ADDENDUM NO. 2

November 2, 2021

CROWN POINT HIGH SCHOOL ADDITIONS AND RENOVATIONS **Crown Point, IN 46307**

This Addendum consists of Pages ADD 2-1 through ADD 2-2 and attached Addendum No. 2 from Gibraltar Design dated October 29, 2021 and consisting of 12 pages, Specification Section 04 01 00 - Masonry Cleaning, Specification Section 12 25 00 - Roller Shades, and 134 drawings.

© GIBRALTAR DESIGN SHEET
T A-117

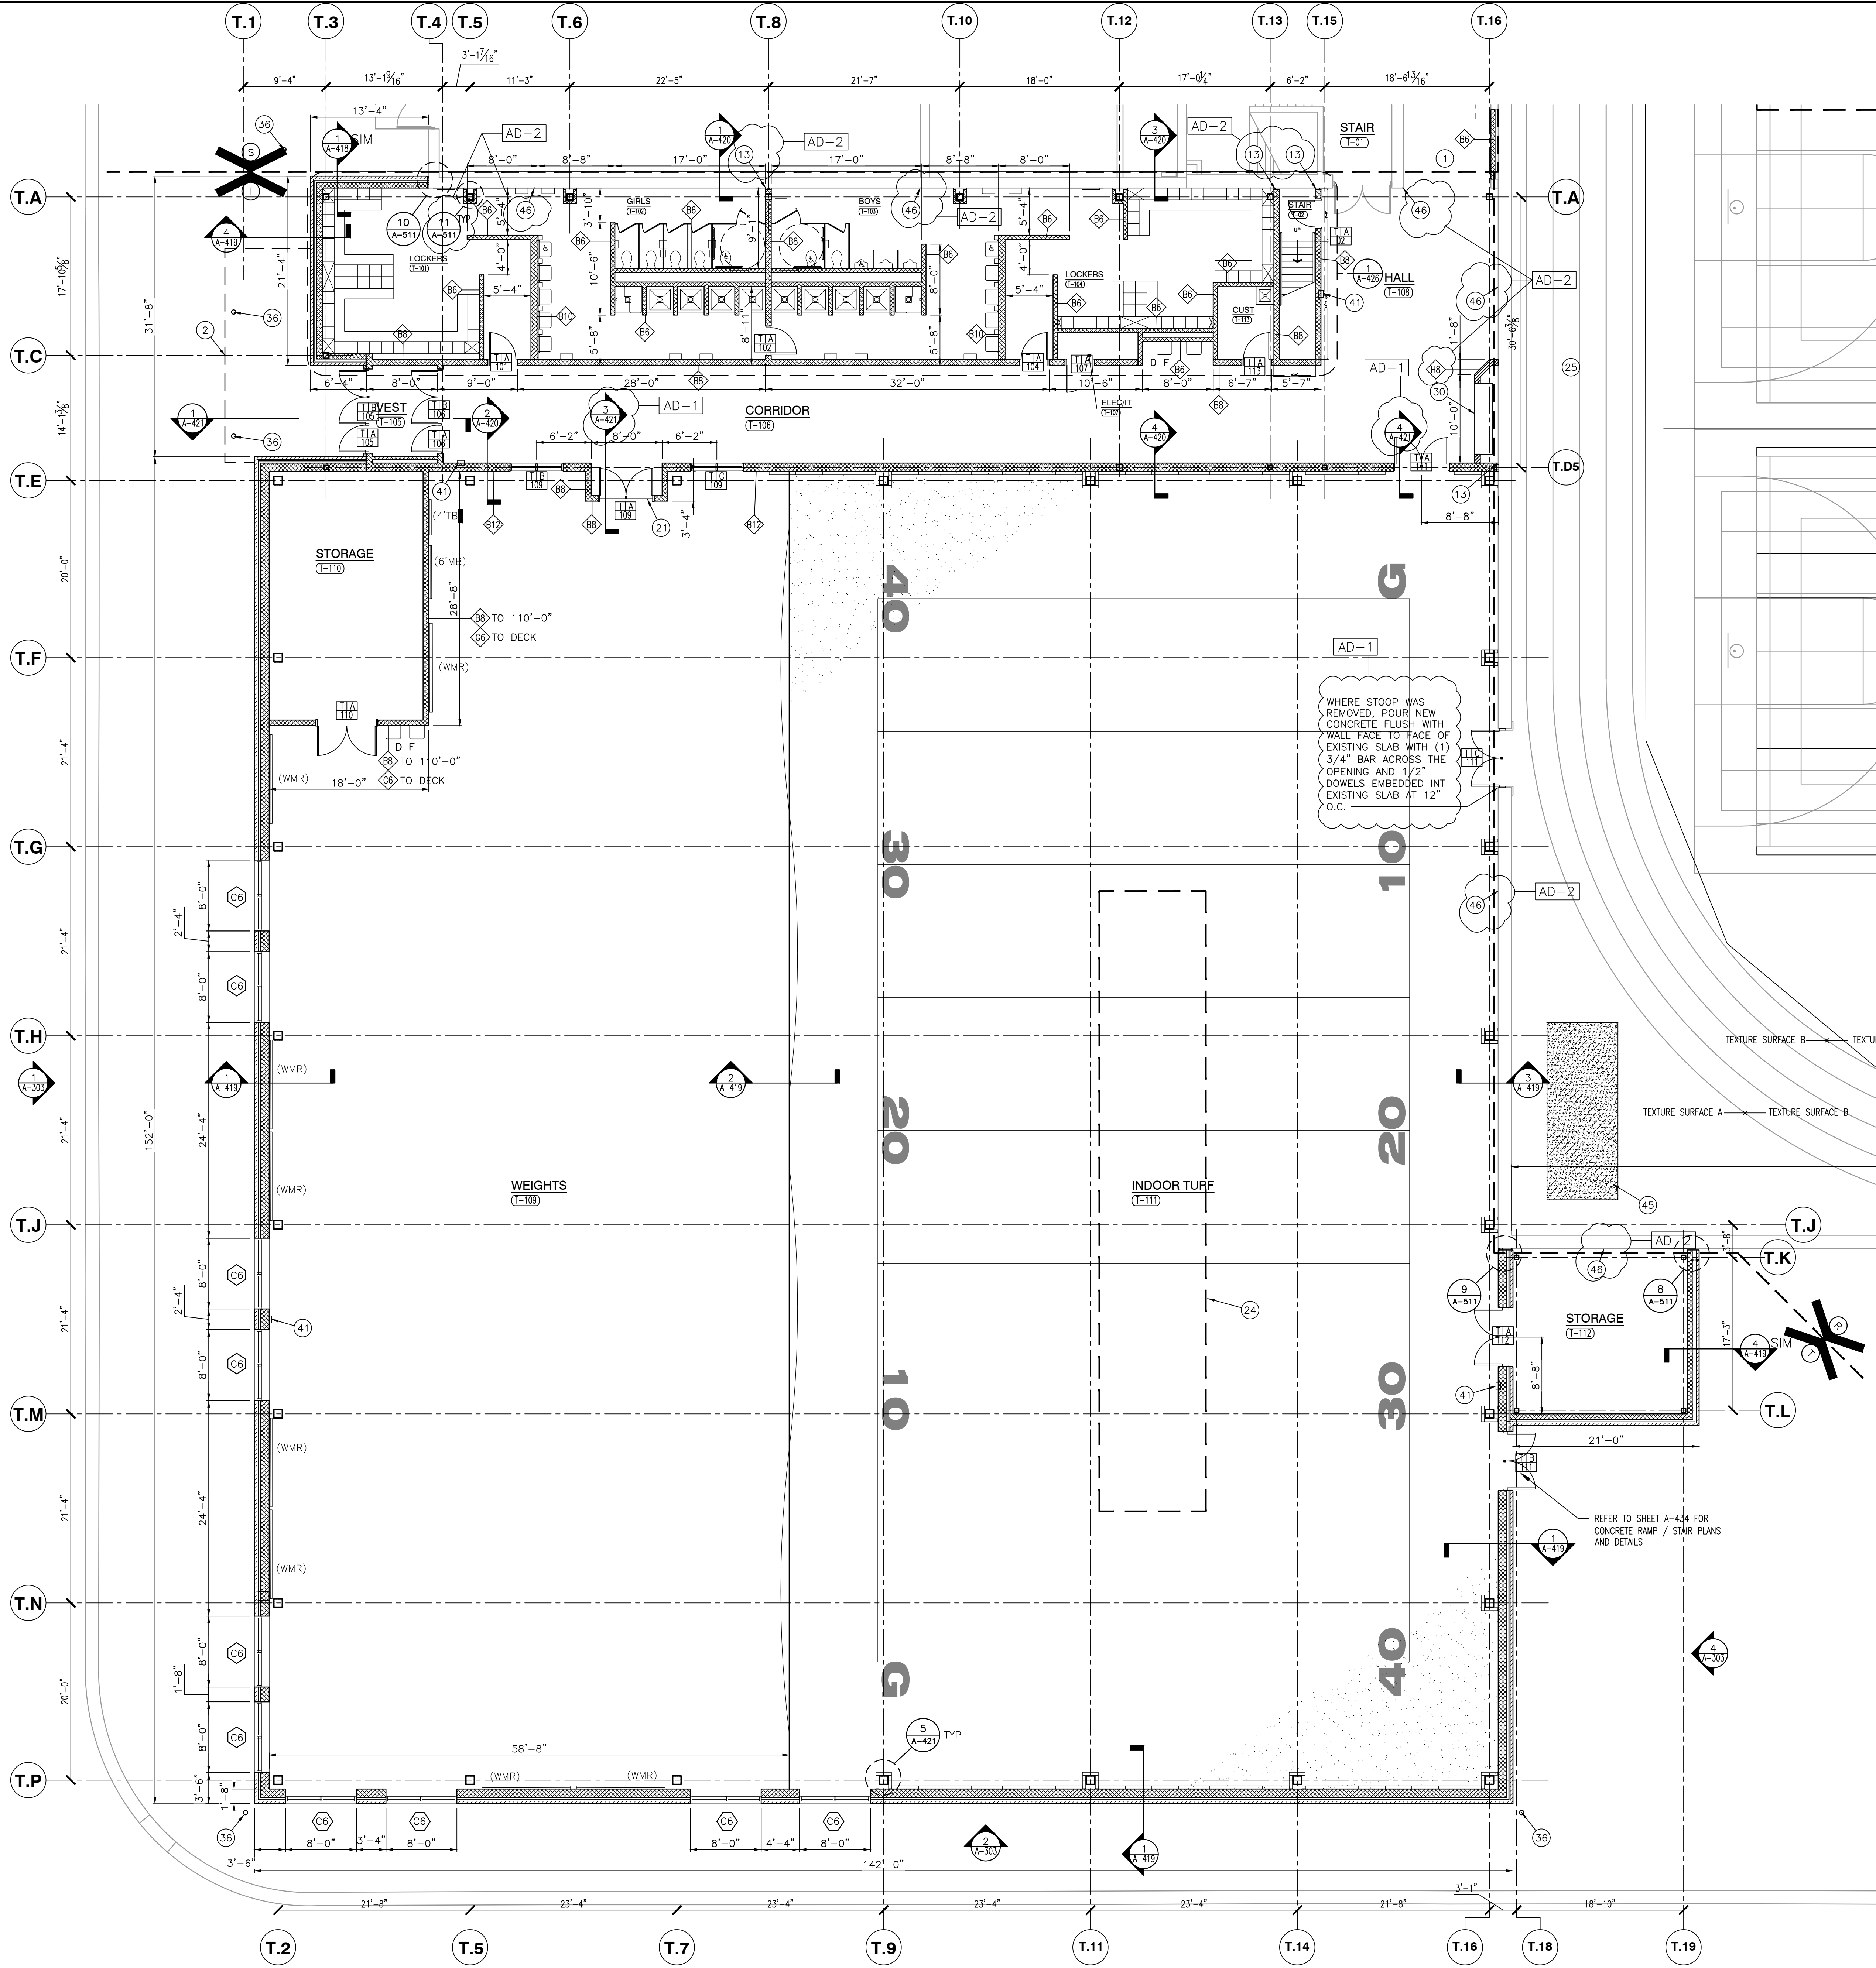
27. Sheet A-117

© GIBRALTAR DESIGN	SHEET
A	A-701

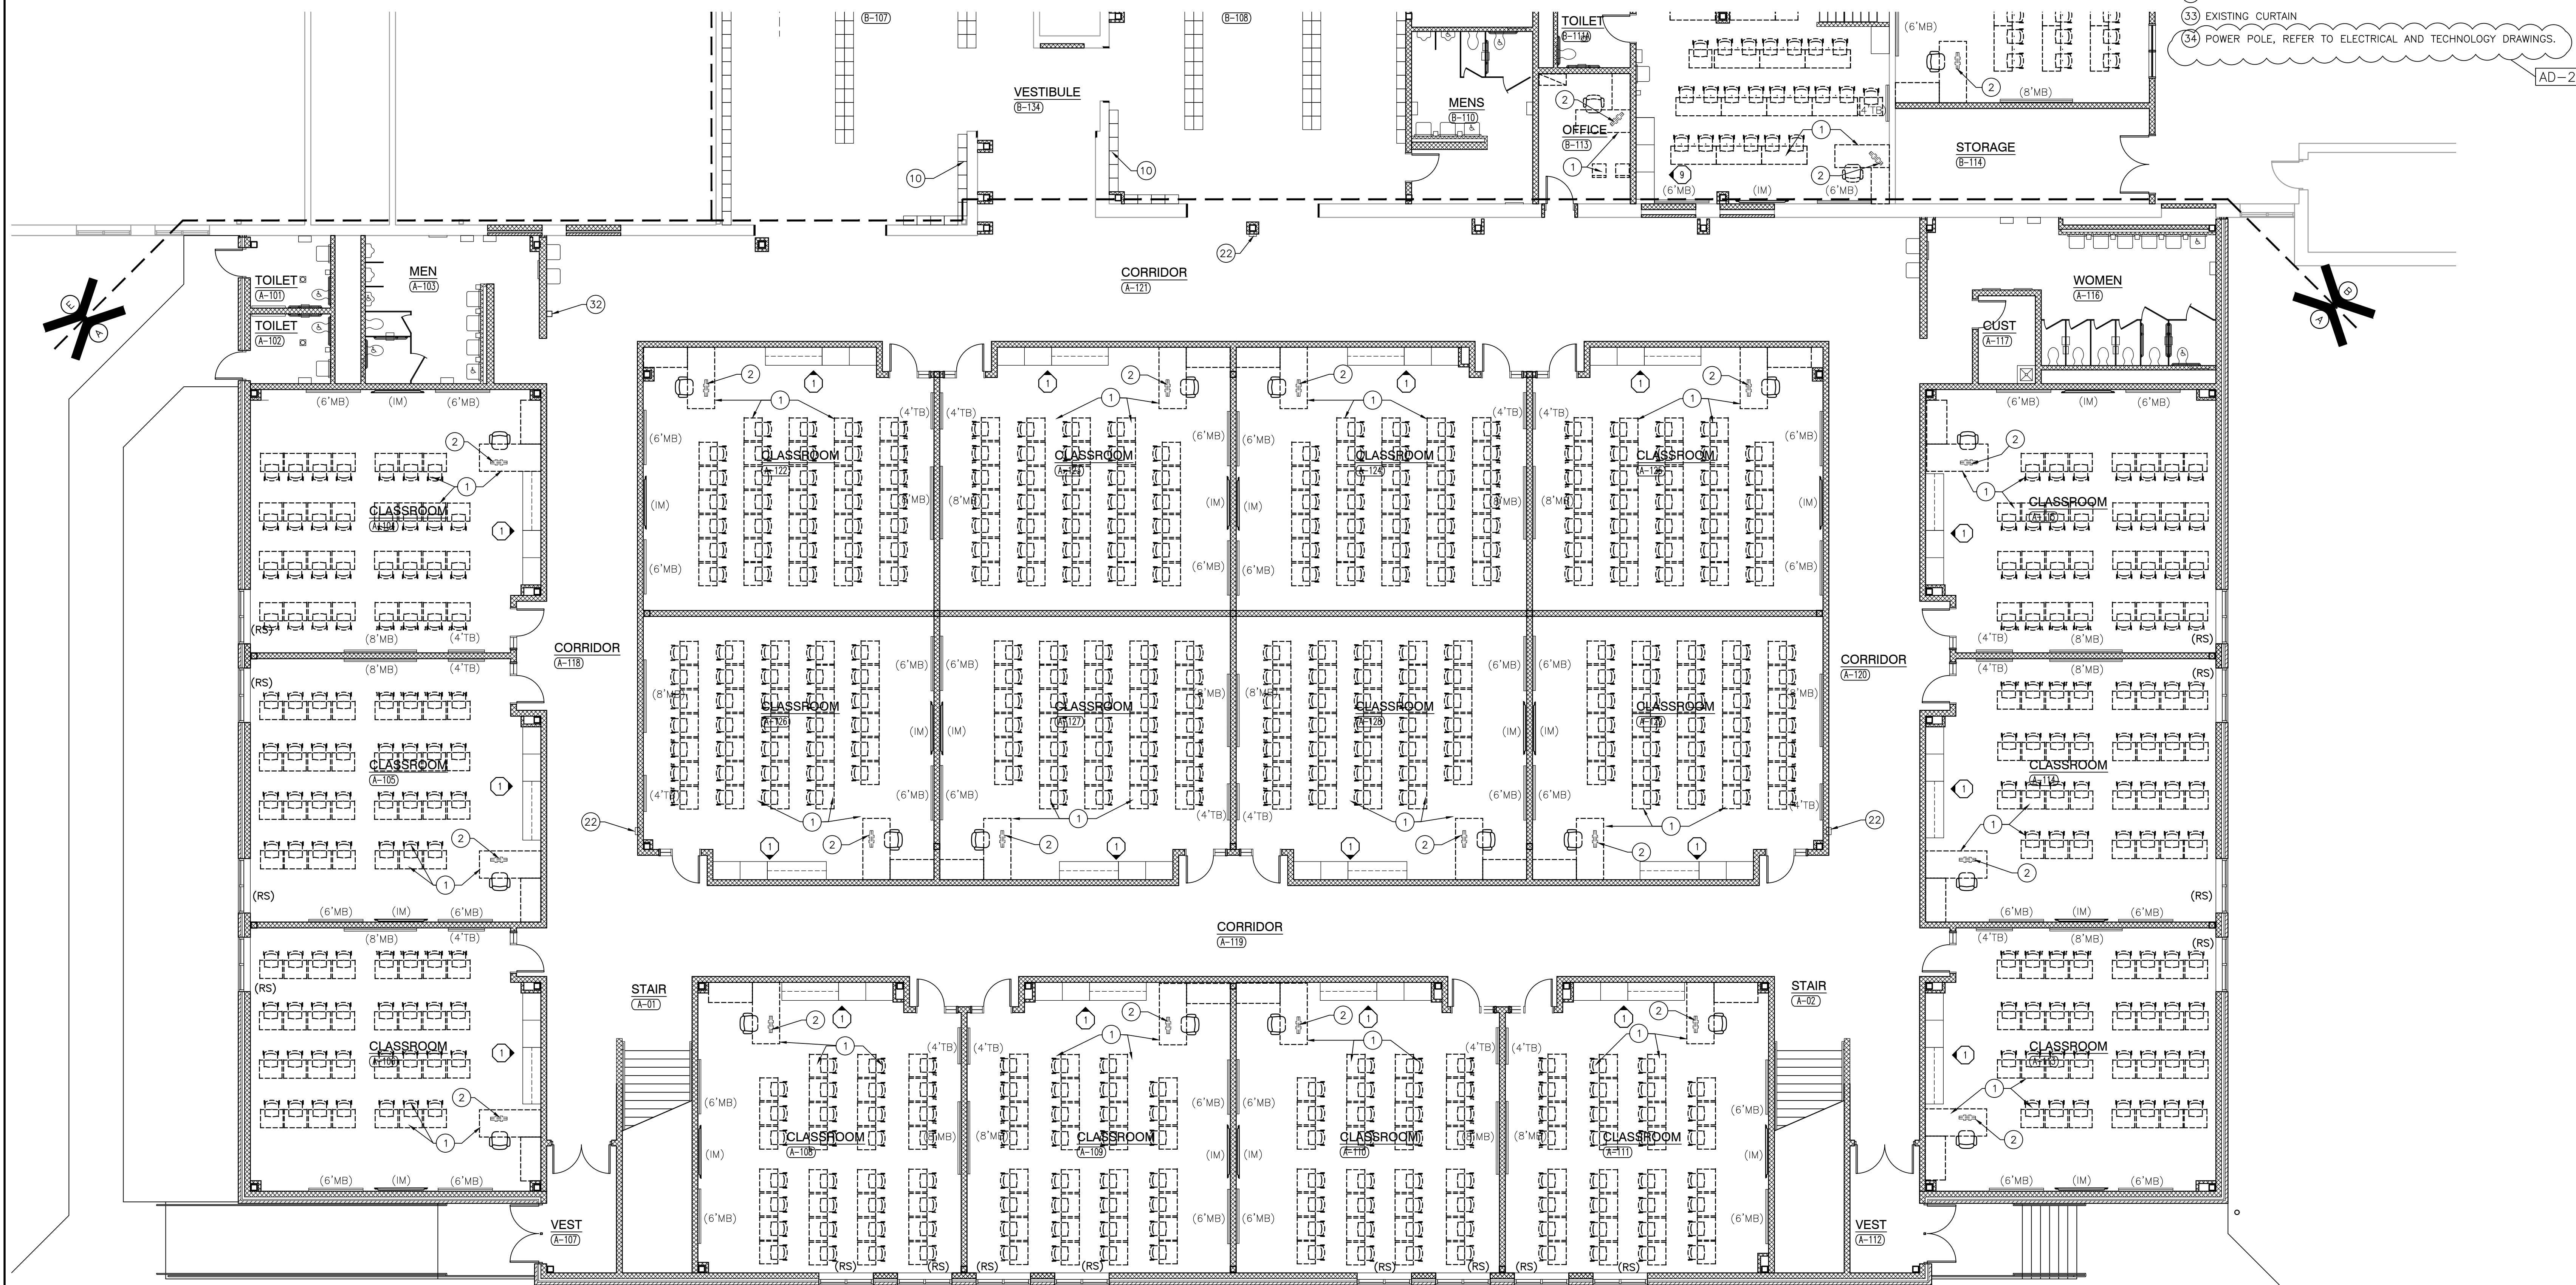
35. Sheet A-701

MD131

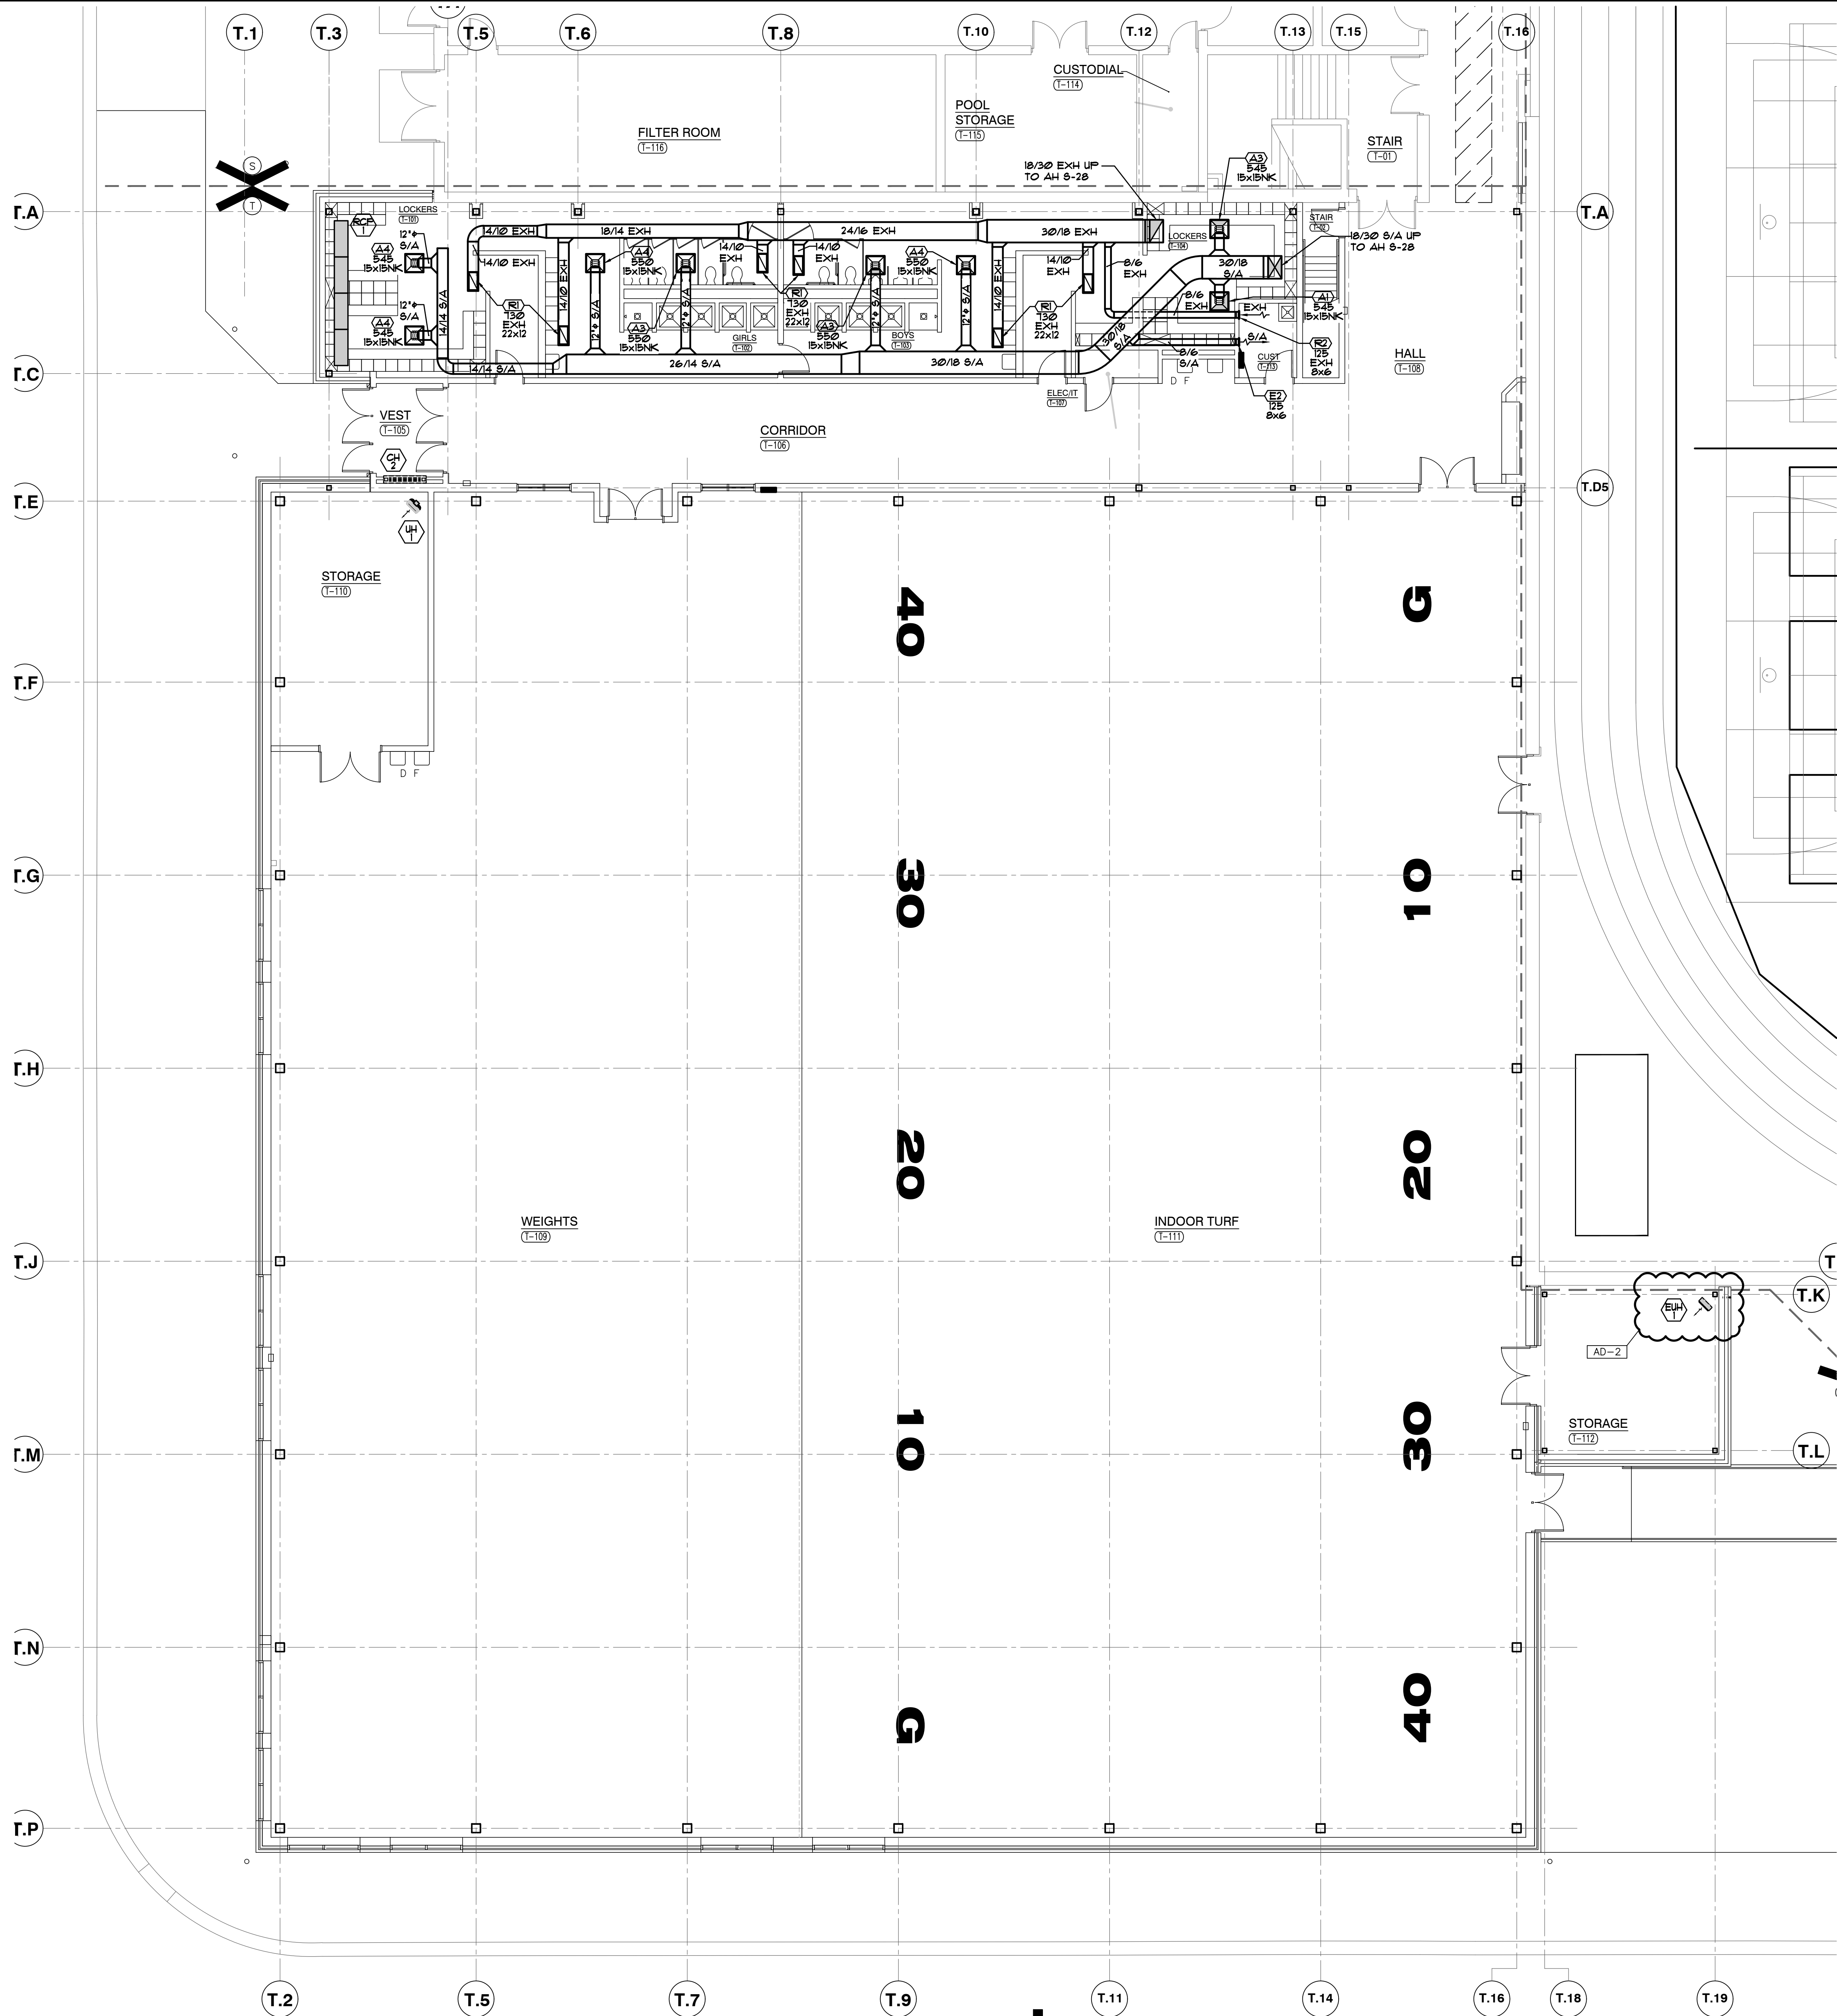
54. Sheet MD-131

- A. Add Sheet MD-131, included in this Addendum, to the Construction Documents.
